Access Compliance Report

Public Rights-of-Way

Intersection ID: 25287	Main Street: CEDAR_POINT_LN	Cross Street: JOHNSTON_RD	Location: NE
ADA ID: 8A667889C4AD	Ramp Type: PerpDiag	Initial Pass/Fail: Fail	Overall Compliance: No
Severity Score: 25			
Codes/Mitigation Info/Possible Solution		Field Measurements/Component Compliance

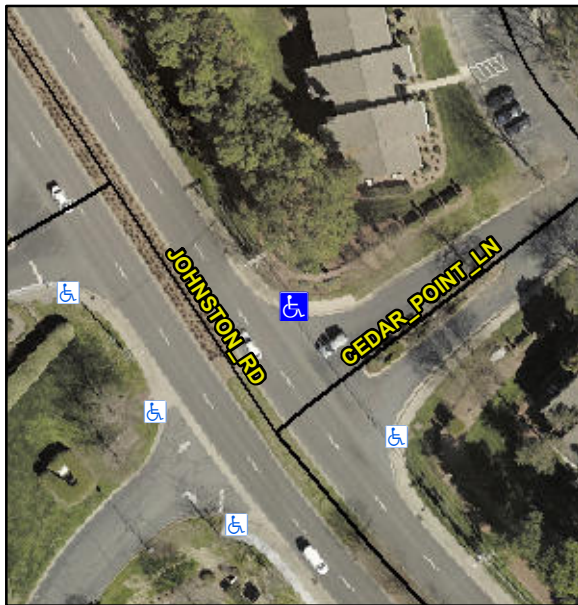
Not Found, R304.2.2, R304.5.3

Compliance	Description	Data	Compliance	Description	Data
N/A	Ramp Length (in)	60.0	No	Ramp Slope (%)	9.2
Yes	Ramp Width (in)	48.0	No	Ramp XSlope (%)	5.5
N/A	Flare Type LT	N/A	N/A	Flare Type RT	N/A
N/A	Flare Slope LT (%)	N/A	N/A	Flare Slope RT (%)	N/A
N/A	Flare Traversable LT?	N/A	N/A	Flare Traversable RT?	N/A
N/A	Landing Length (in)	N/A	N/A	DWS Provided?	N/A
N/A	Landing Width (in)	N/A	N/A	DWS Contrast?	N/A
N/A	Landing Slope (%)	N/A	N/A	DWS Length (in)	N/A
N/A	Landing X Slope (%)	N/A	N/A	DWS Full Width?	N/A
N/A	Landing Curb? (Y/N)	N/A	N/A	DWS Offset (in)	N/A
N/A	Shared Landing?	N/A			
N/A	Gutter Ponding?	N/A	N/A	Gutter Slope (%)	N/A
N/A	Gutter Lip Ht (in)	N/A	N/A	Gutter X Slope (%)	N/A
N/A	Painted X Walk1?	No	N/A	Painted X Walk2?	No
	X Walk 1 Direction	To SW		X Walk 2 Direction	To SE
N/A	X Walk 1 Width (in)	N/A	N/A	X Walk 2 Width (in)	N/A
	X Walk 1 Slope (%)	4.1		X Walk 2 Slope (%)	1.9
	X Walk 1 X Slope (%)	3.5		X Walk 2 X Slope (%)	4.5

Remove & Replace Curb Ramp With Two New Directional Ramps or Equivalent.
